ARCHITECTURAL REVIEW BOARD MEETING
CITY HALL, 385 SOUTH GOLIAD, ROCKWALL, TEXAS
JUNE 14, 2022 IN THE CITY COUNCIL CONFERENCE ROOM AT 5:00 PM

PLANNING AND ZONING COMMISSION CASE MEMO

TO: Planning and Zoning Commission
DATE: June 14, 2022
APPLICANT: David Gregory; *DCG Engineering, Inc.*
CASE NUMBER: SP2022-025; *Site Plan for Einstein Bros Bagel*

SP2022-026: Site Plan for Qdoba

DRAWING TITLE:
EXTERIOR ELEVATIONS

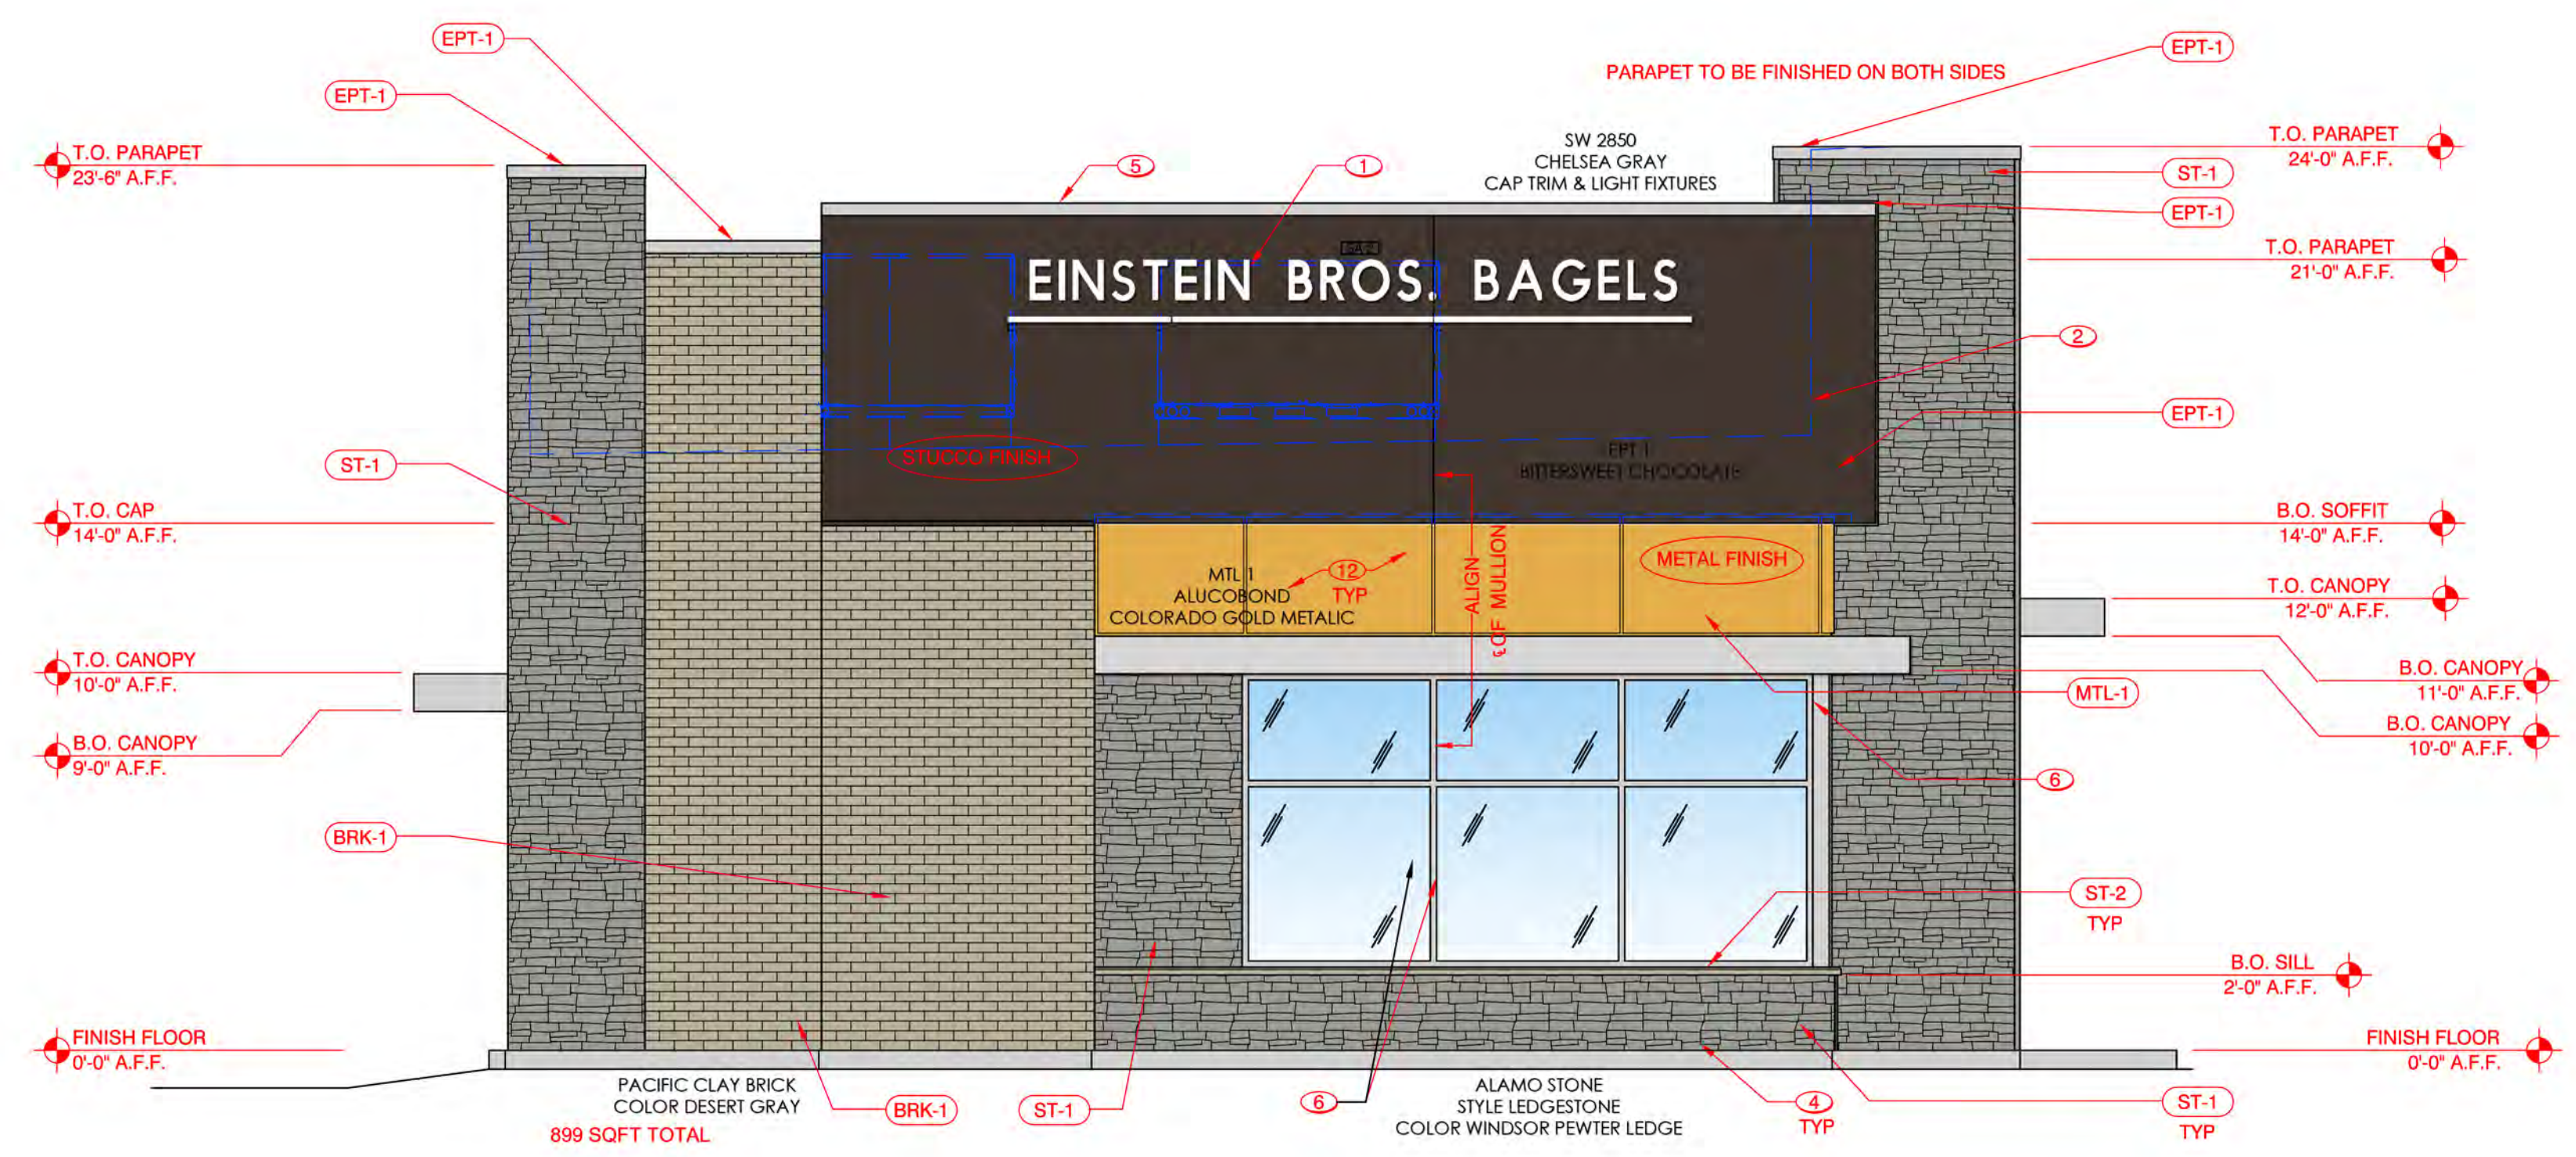
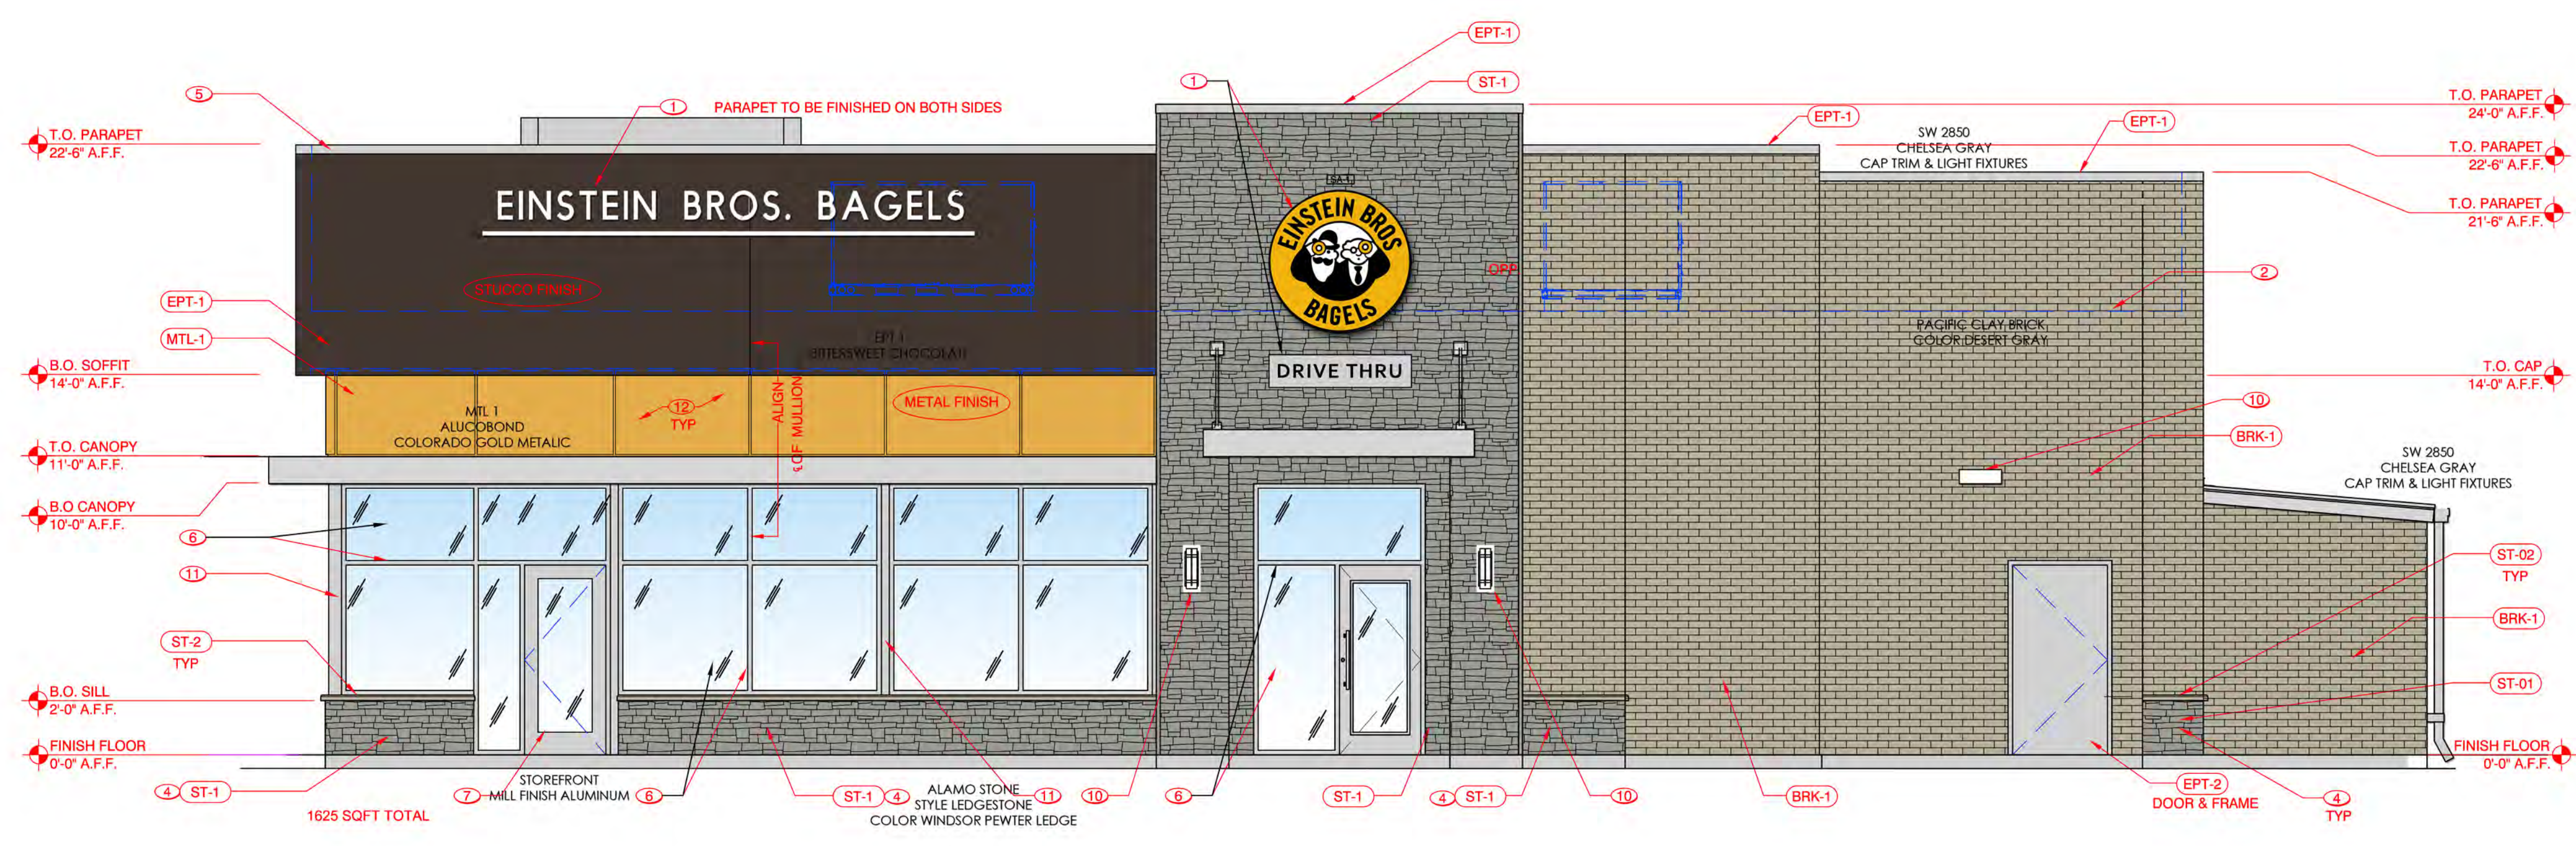
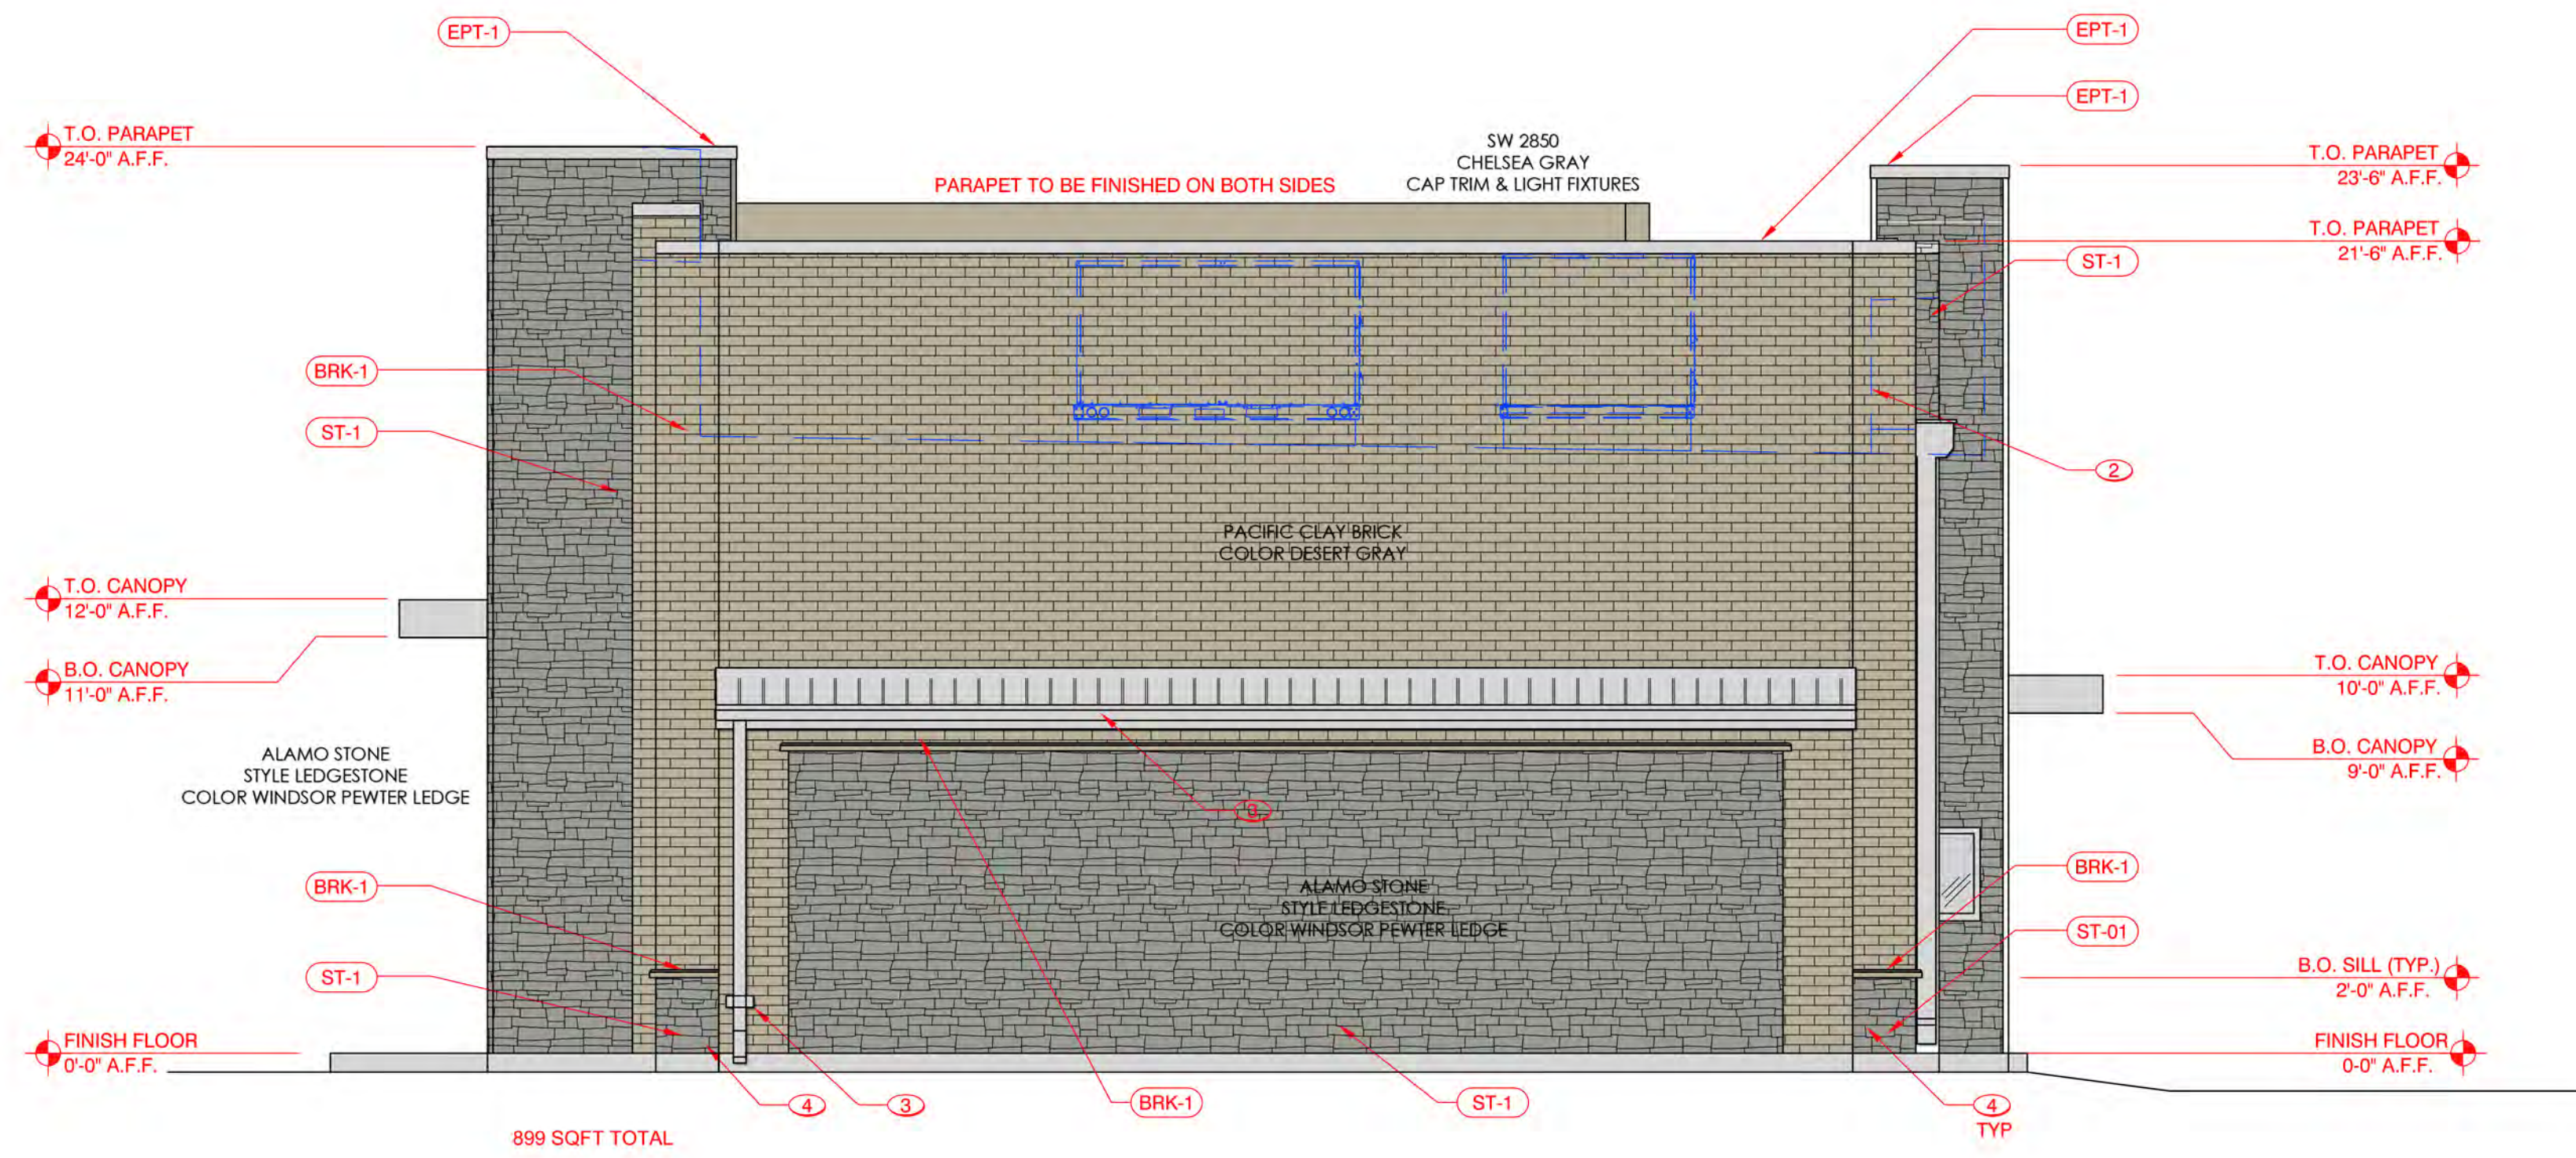
The Architectural Review Board (ARB) reviewed the building elevations provided by the applicant on May 31, 2022, and made the following recommendations: [1] provide stone up the tower elements, [2] break-up the drive-through façade with a bump

out, [3] clad the equipment screening on the rear of the building in brick/stone, and [4] provide a similar color palette and materials as the Dutch Bros Coffee. As an example of consistent design, the ARB directed the applicant to review the buildings at the southwest corner of N. Goliad Street and N. Lakeshore Drive. Before action is taken on the building elevations, the ARB will review the applicant's revised building elevations and provide a recommendation to the Planning and Zoning Commission at the June 16, 2022 meeting.
